APPLIED
RESEARCH
LABORATORIES
THE UNIVERSITY OF TEXAS
AT AUSTIN

QUARTERLY PROGRESS REPORT NO. 2
UNDER CONTRACT N00024-70-C-1117
1 April - 30 June 1970

NAVAL SHIP SYSTEMS COMMAND
Contract N00024-70-C-1117
Proj. Ser. No. SF 1990301, Task 01467

2. Comments on GD/E QPR No. 7

FIGURE A-1
BLOCK DIAGRAM OF SAMPLED TRANSVERSAL FILTER WITH INTERMEDIATE INTENSITY AVERAGER

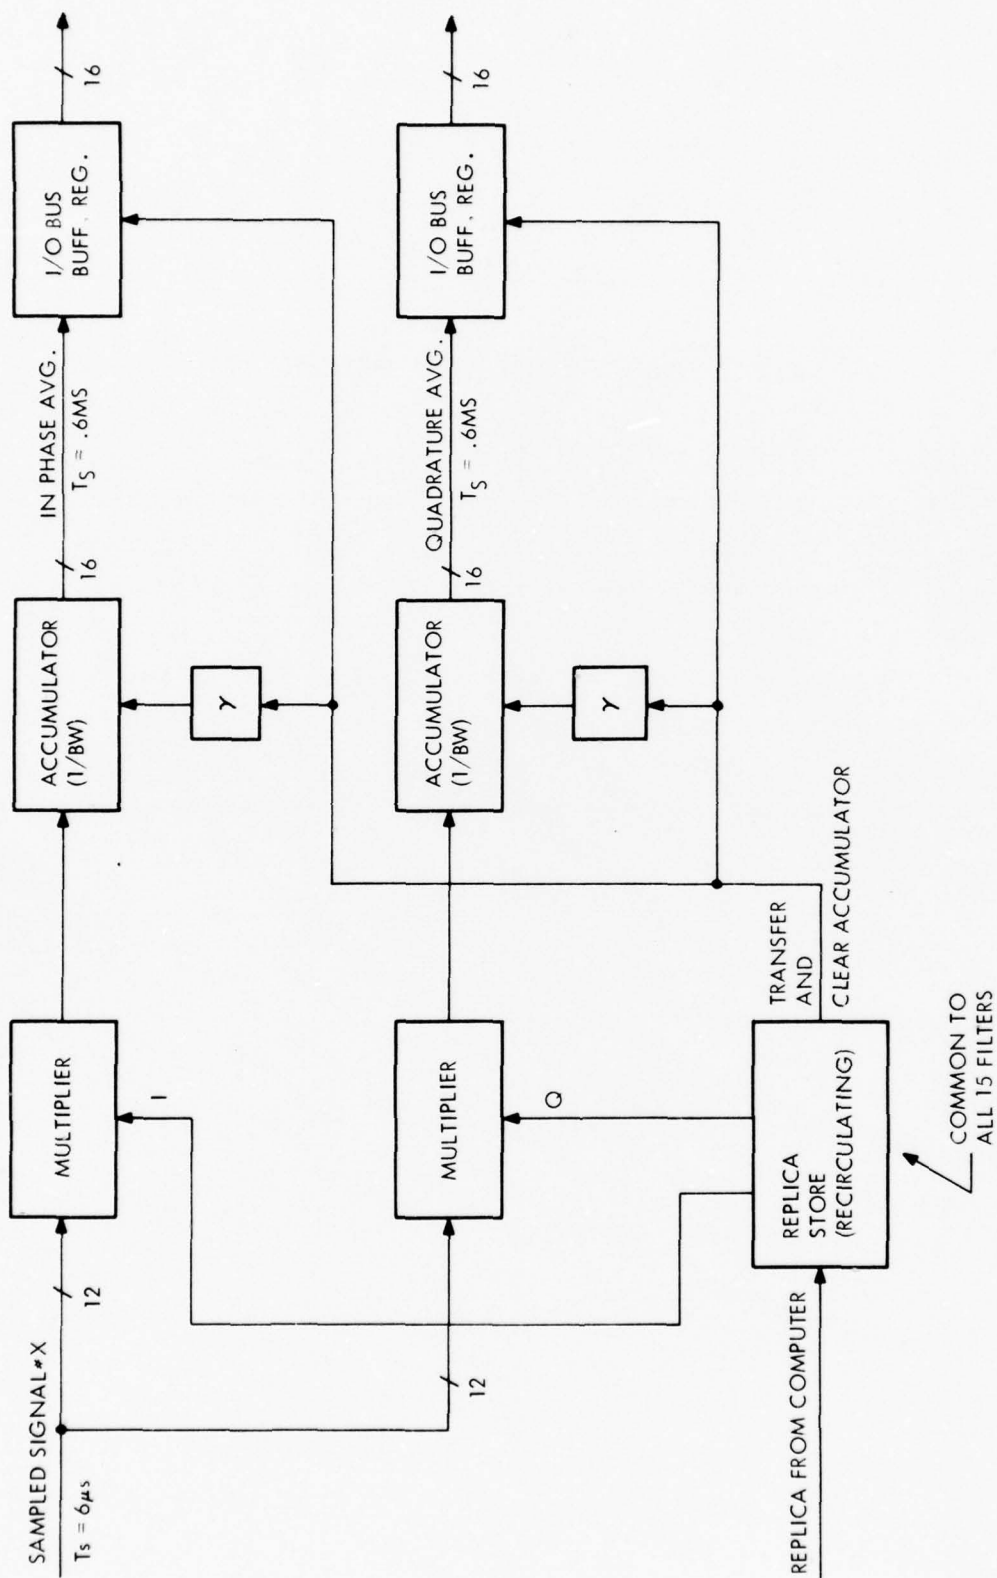
The filter shown in Fig. A-1 is essentially a Fourier transform. If the frequency of interest is f , then the "in-phase replica" from the computer is $\sin 2\pi ft$ and the "quadrature replica" is $\cos 2\pi ft$. The mathematical operations performed by this filter can be written as:

experimenter in any experiment is to control as many variables as possible. It was further pointed out by ARL that the 16-bit accumulator shown in Fig. A-1 might not provide sufficient resolution for a 14.4 msec integration time. GD/E acknowledged that they had not analyzed the resolution requirement placed on this accumulator by such an extended integration time. They stated that this would be done before the next N/CC set for 17-18 June 1970.

In a telephone call on 25 June 1970, ARL recommended to GD/E a method that might allow the data reduction to be accomplished in real-time. The system would be identical to that shown in Fig. A-1 and A-2 except that the REPLICA STORE shown in Fig. A-1 would be
